Kansas Department of Agriculture  
 Division of Water Resources  
**CHANGE: P/D WORKSHEET**

RE: Change in Point of Diversion Water Right, File No 26393

## DWR FIELD OFFICE APPLICATION FOR APPROVAL TO CHANGE THE PLACE OF USE AND/OR THE POINT OF DIVERSION

## GMD3 Change Review

# 26393 Change Review; PD

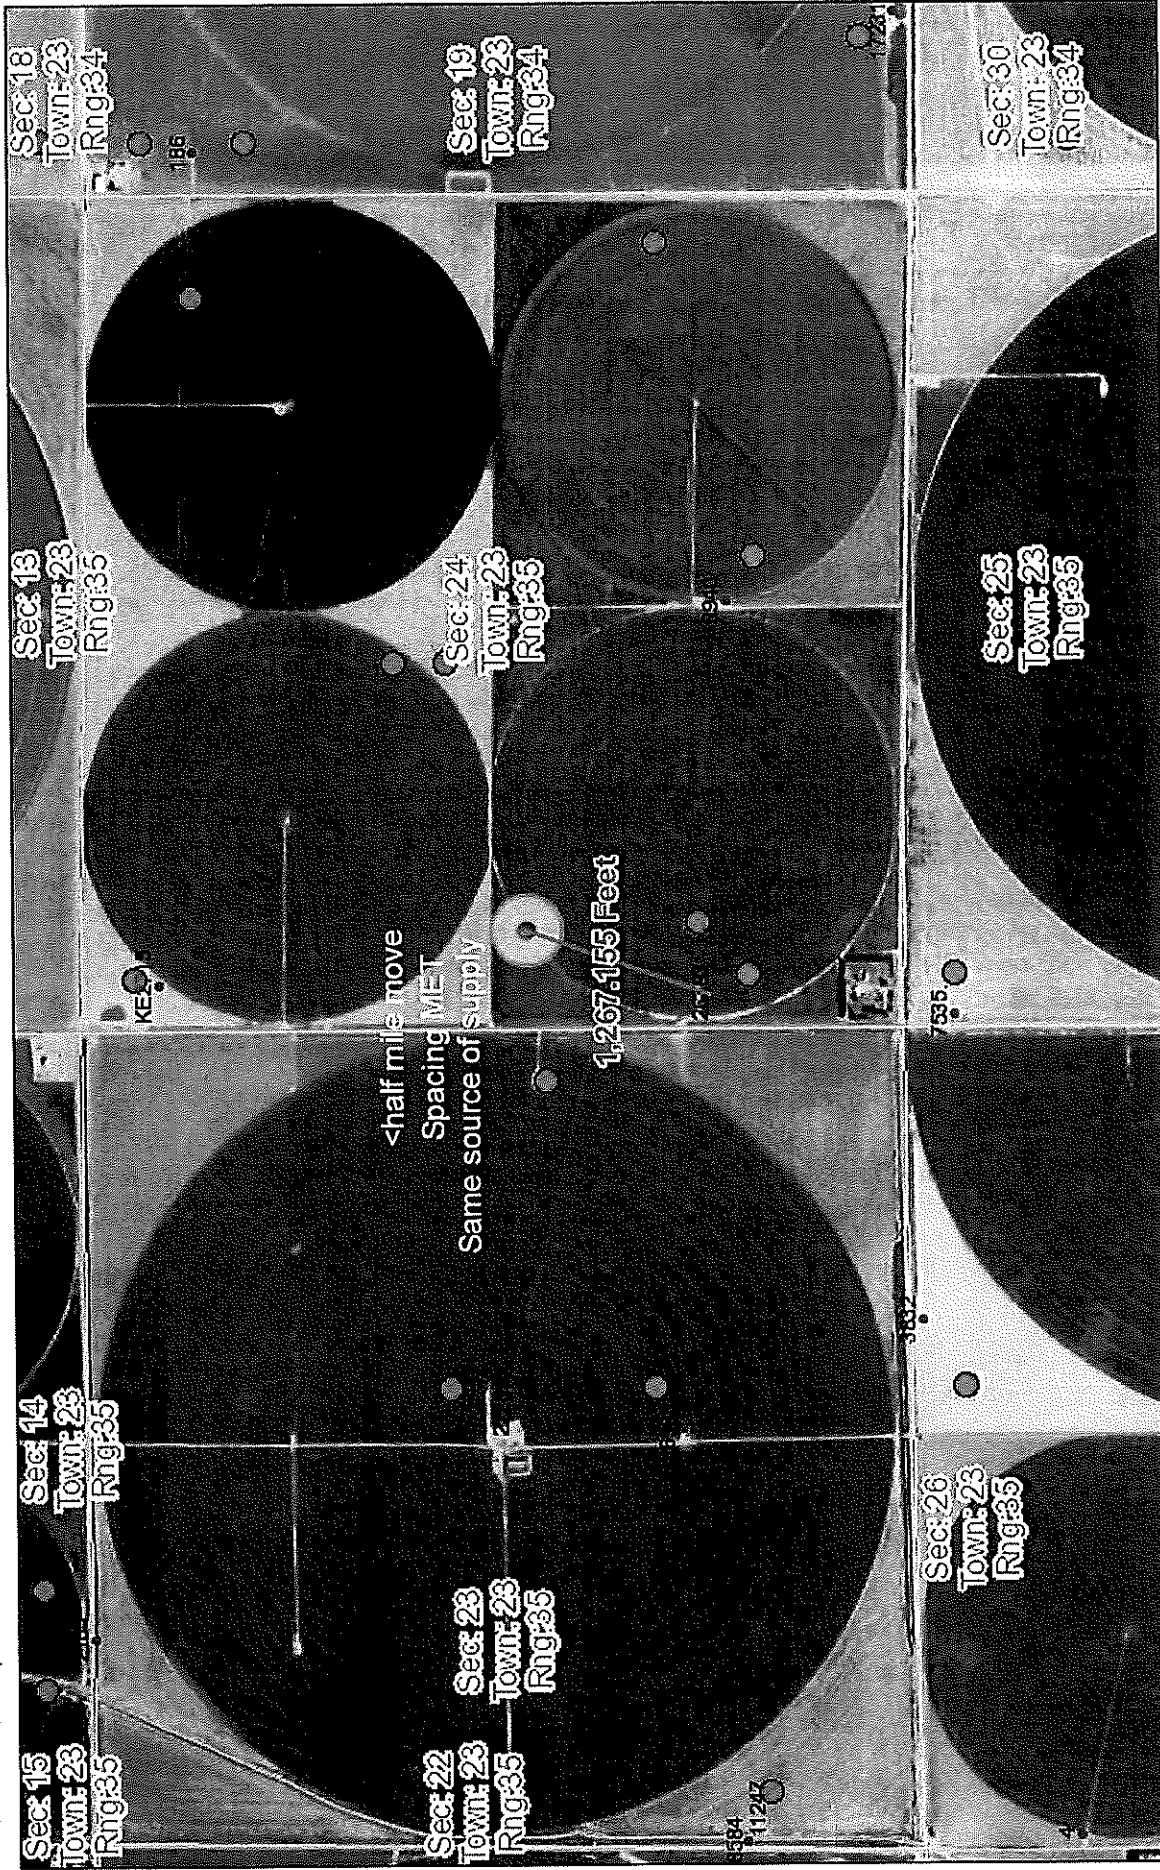
**Move less than half mile and meets spacing to neighbors.**

**Log appears to show same aquifer**

*Spacing MET!*  
*[Signature]*

Final Recommendation: After review of all available information, it appears current area rules are met. Staff therefore recommends approval of the application.
